# HIGHWAY WORK PROPOSAL

Proposal Number: **016**

<u>COUNTY</u>	<u>STATE PROJECT</u>	<u>FEDERAL</u>	<u>PROJECT DESCRIPTION</u>	<u>HIGHWAY</u>
Milwaukee	2656-00-72	N/A	C Milwaukee S 70th Street; Bridge Over Cp Rr/Hast P-40-856	LOC STR

Addendum No. 01  
 ID 2656-00-72  
 Revised Sheet 14  
 March 8, 2023

Addendum No. 01  
 ID 2656-00-72  
 Revised Sheet 35  
 March 8, 2023

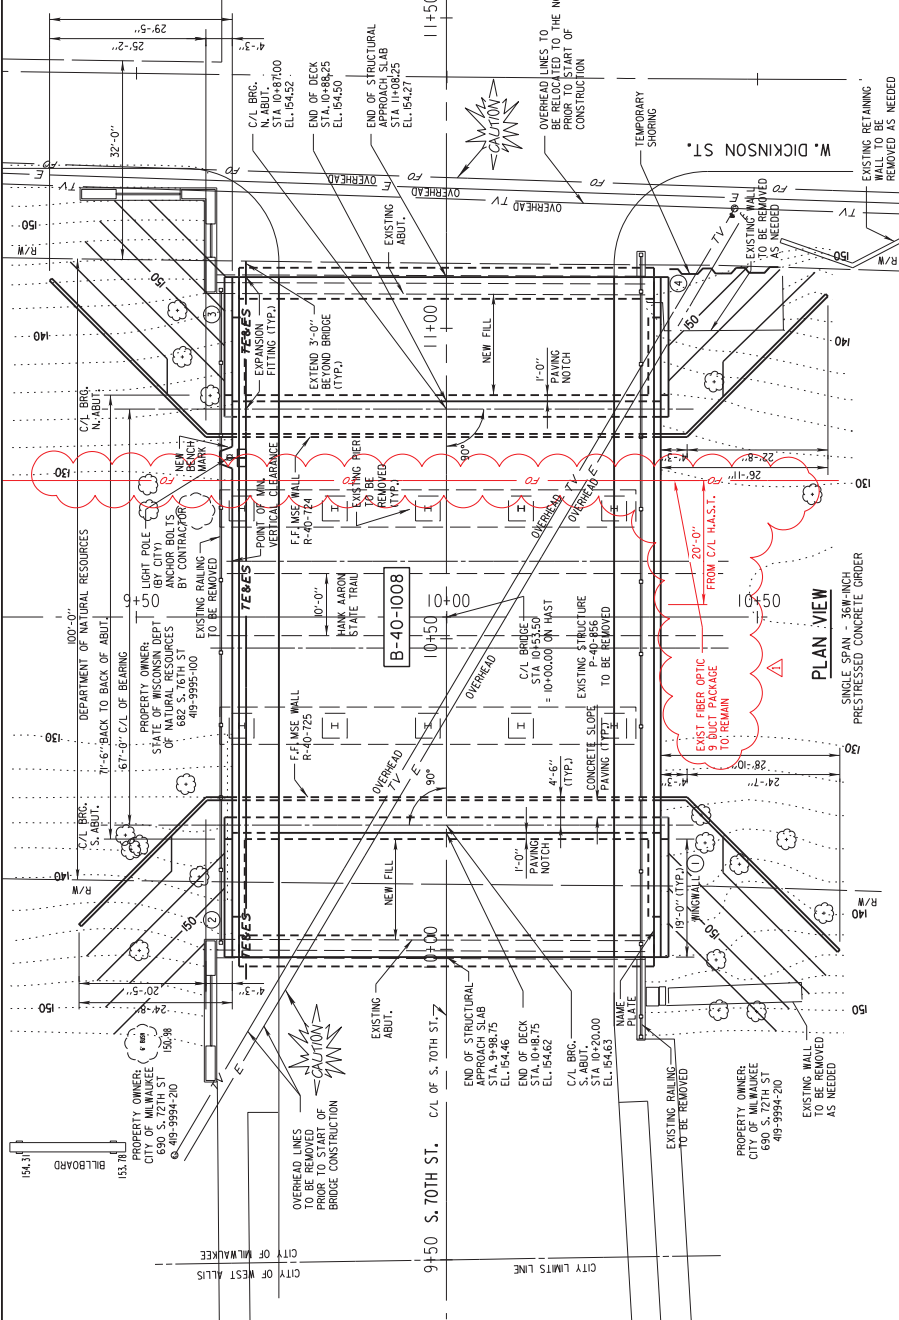
**AT&T FIBER OPTIC PROTECTION**

CATEGORY 0020	999.2005.S	AT&T FIBER OPTIC PROTECTION EACH	1
<hr/>			
LOCATION	S. 70TH STREET		
<hr/>			
TOTAL			1

**SITE PLAN AND  
ELEVATION**  
SHEET 1 OF 25  
117

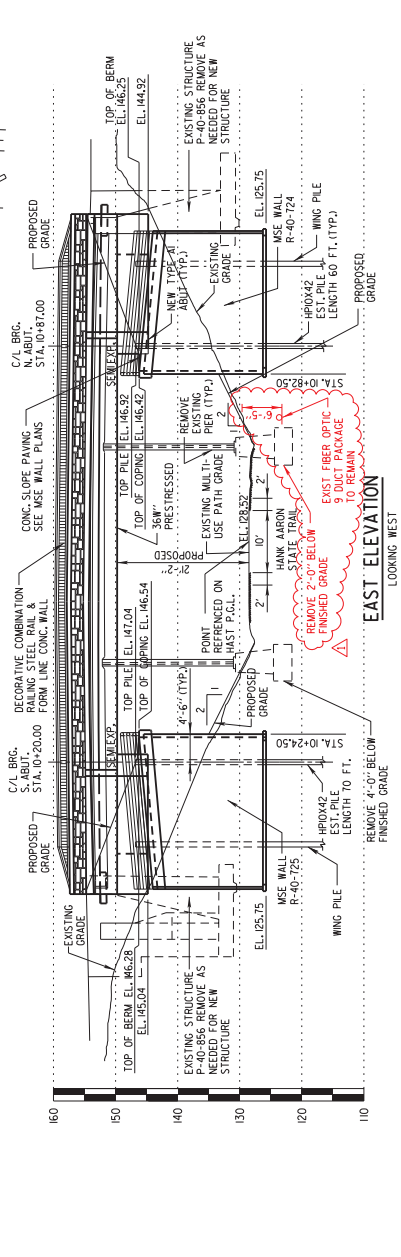
NO.	DATE	REVISION	BY
1	3/2/23	ADD #1 - EXISTING AT&T CORP.	S.S.R.
